BEFORE THE MERIDIAN CITY COUNCIL

**CASE NO. FP-2021-0059
ORDER OF CONDITIONAL
APPROVAL OF FINAL PLAT**

HEARING DATE: 1/4/2022
TO: Mayor & City Council
FROM: Sonya Allen, Associate Planner
208-884-5533
SUBJECT: FP-2021-0059
Southridge South No. 1
LOCATION: South side of W. Overland Rd., 1/4 mile east of S. Ten Mile Rd., in the NW 1/4 of Section 23, T.3N., R.1W.

Final plat consisting of 76 single-family residential building lots and 8 common lots on 16.99 acres of land in the R-8 zoning district for the first phase of Southridge South Subdivision.

B. Final Plat (date: 12/6/2021)

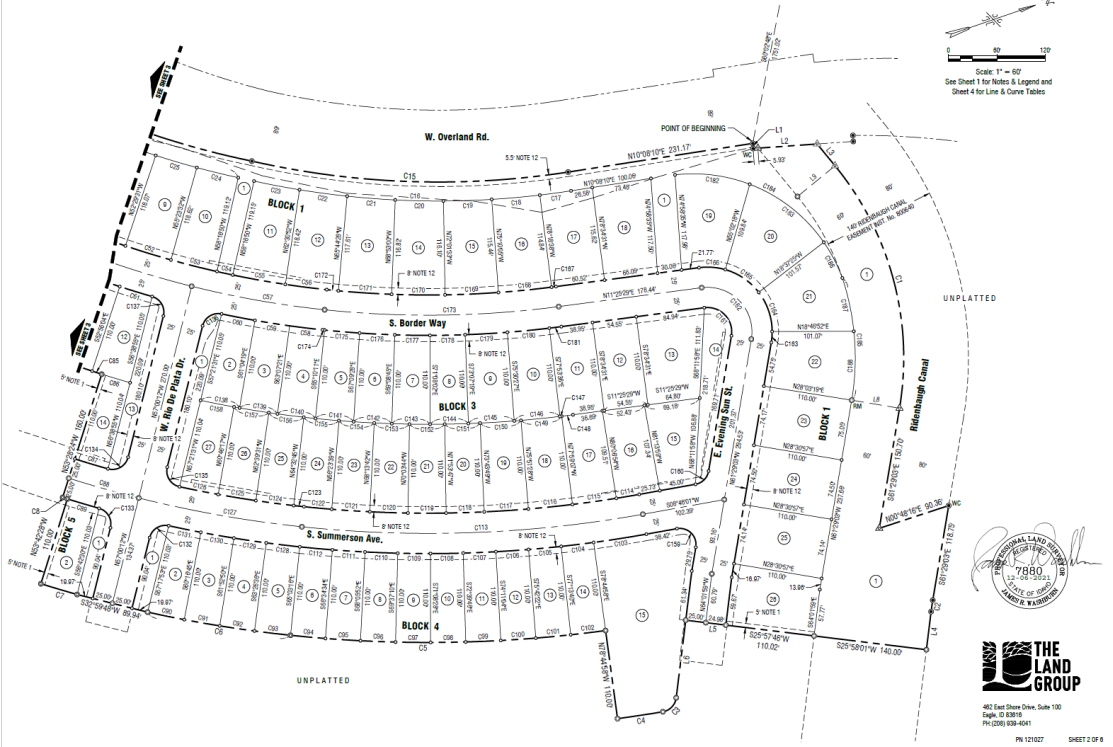
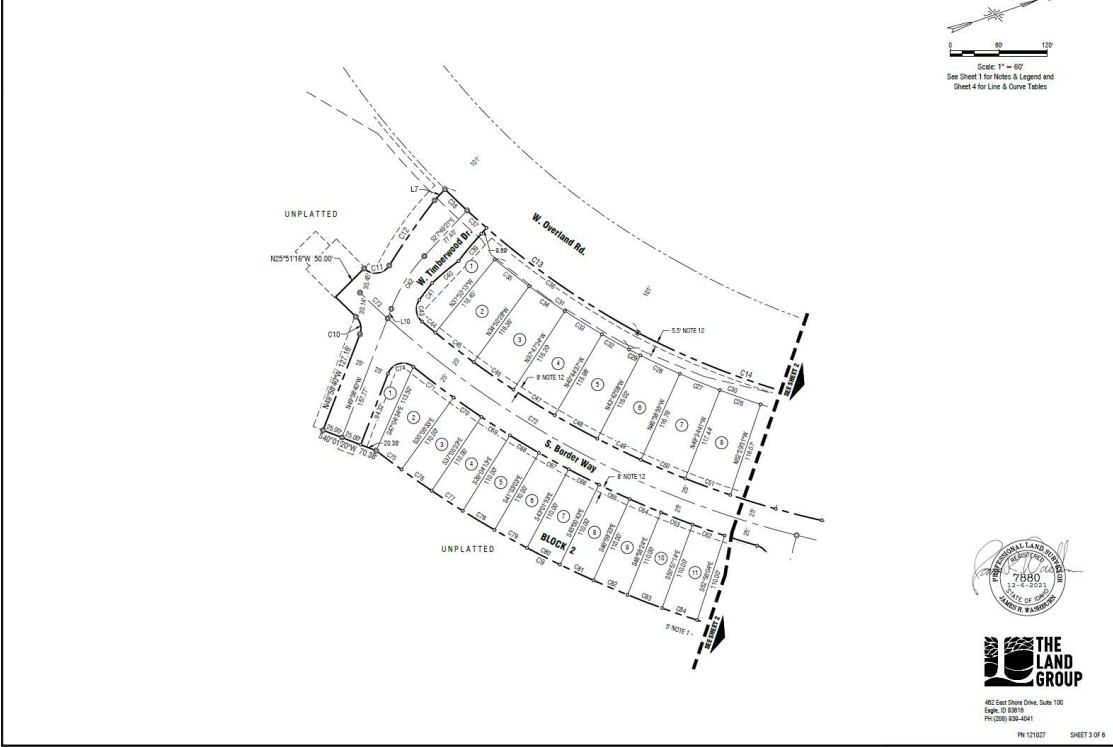
3. Prior to submittal for the City Engineer’s signature, have the Certificate of Owners and the accompanying acknowledgement signed and notarized.
4. The final plat shown in Section V.B prepared by The Land Group, stamped on 1/15/2021 by James R. Washburn, shall be revised as follows:

- a. Note #6: “. . . Lots 1 and ~~13~~ 14, Block 3;
 - b. Note #10: Include recorded instrument number of the CC&R’s.
 - c. Note #11: Include recorded instrument number for the ACHD license agreement.

- d. Depict water and sewer easements on the portion of Lot 1, Block 1 that lies between Lots 18 and 19.

An electronic copy of the revised plat shall be submitted prior to signature on the final plat by the City Engineer.

C. Landscape Plan (date: 11/17/2021)

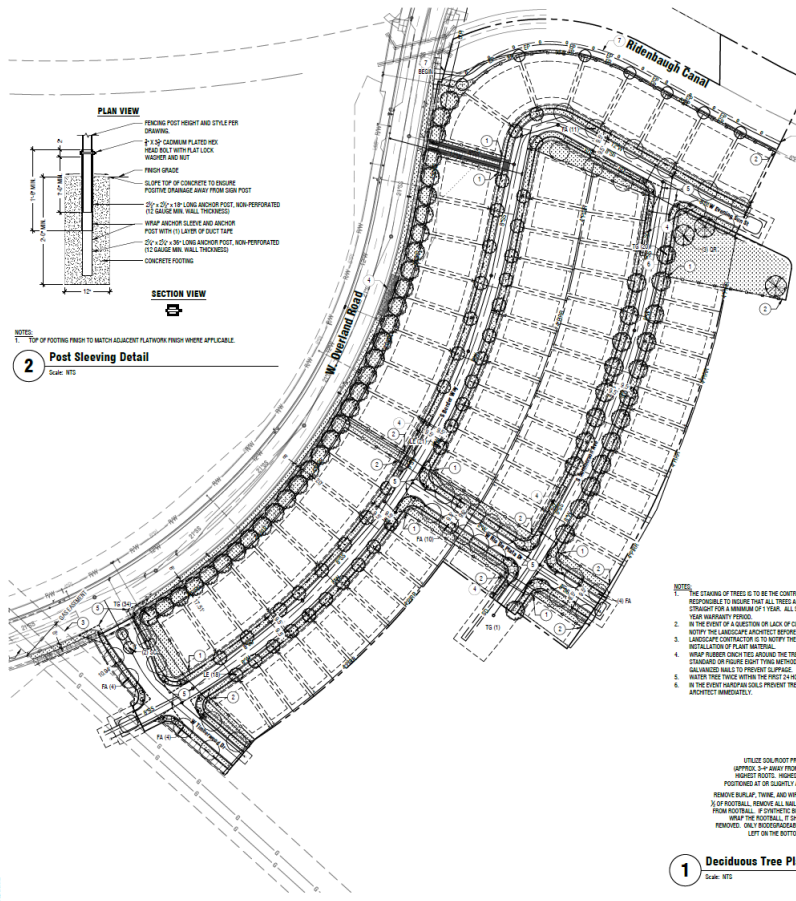
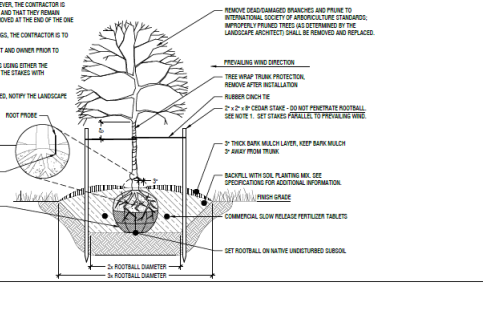
5. The landscape plan shown in Section V.C, dated 2/7/20, shall be revised as follows:
 - a. Depict shrubs (along with the proposed trees) within the street buffer along W. Overland Rd. as set forth in UDC [11-3B-7C.3a](#) per preliminary plat condition #4a.

- b. Landscaping shall be depicted along *all* pathways in accord with the standards listed in UDC [11-3B-12C](#); include a *mix* of trees (minimum of 1 per 100 linear feet of pathway), shrubs, lawn, and/or other vegetative groundcover per preliminary plat condition #4b. *If landscaping (trees) is not allowed within NMID’s easement for the Ridenbaugh Canal, an additional minimum 5-foot wide area shall be provided outside of the easement in a common lot(s) for the required trees.*

- c. Correct Project Calculations table for residential subdivision (i.e. parkway) trees – a minimum of one tree is required per 35 linear feet of parkway as set forth in UDC [11-3B-7C](#), excluding 26 feet for curb cuts to each residential lot (the requirement is not one per lot as stated). Include linear feet of pathway; required number of residential subdivision trees; and common open space area and required vs. proposed number of trees that demonstrate compliance with code requirements per preliminary plat condition #4d.

- d. The fencing type along the Ridenbaugh Canal shall be black wrought iron as required by City Council; depict accordingly.

An electronic copy of the revised landscape plan shall be submitted prior to signature on the final plat by the City Engineer.
